SITE PLAN REVIEW AND APPEARANCE BOARD STAFF REPORT

318 SE 5th Avenue

Meeting	File No.	Application Type
March 22, 2023	2022-013-SPF-SPR-CLV	Class V Site Plan
Property Owner	Agent	
318 SE 5 th LLC	Jerrod Purser, WGI

Consideration of a Class V Site Plan, Landscape Plan, and Architectural Elevations for the construction of a four-story, mixed-use development located at the properties currently addressed as 302, 318, 338, and 346 SE 5th Avenue.

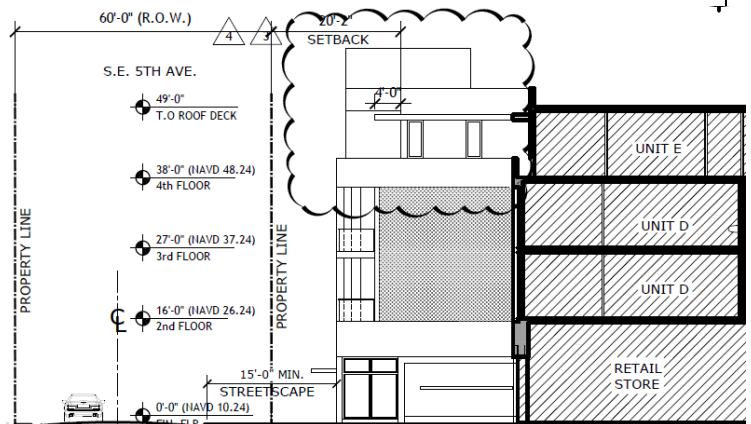
Note that special consideration should be given as to whether the pedestrian passageway meets the intent of the LDR. Specifically, **LDR Section 4.4.13(D)(2)(a)(6)** states that a building with more than 250 feet of street frontage shall provide a pedestrian/bicycle passageway of at least 10 feet wide connecting rear alleys and/or parking to the public sidewalk. The development proposes a 10-foot-wide pedestrian passageway on the north side of the building, connecting the civic open space to the parking in the rear.
